Product / Process Change Notification (PCN)

PCN #: PCN_IndHCC_20210122

Affected Series: WE-HCC 744334xxxx

Before Change

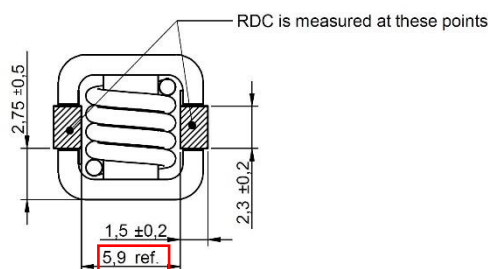
Because of a datasheet mismatch, Würth Elektronik will correct the reference dimension between the clips. There will be no change in form, fit, function, quality or reliability of the product.

The dimension will be corrected from 5,9mm to 5,4mm.
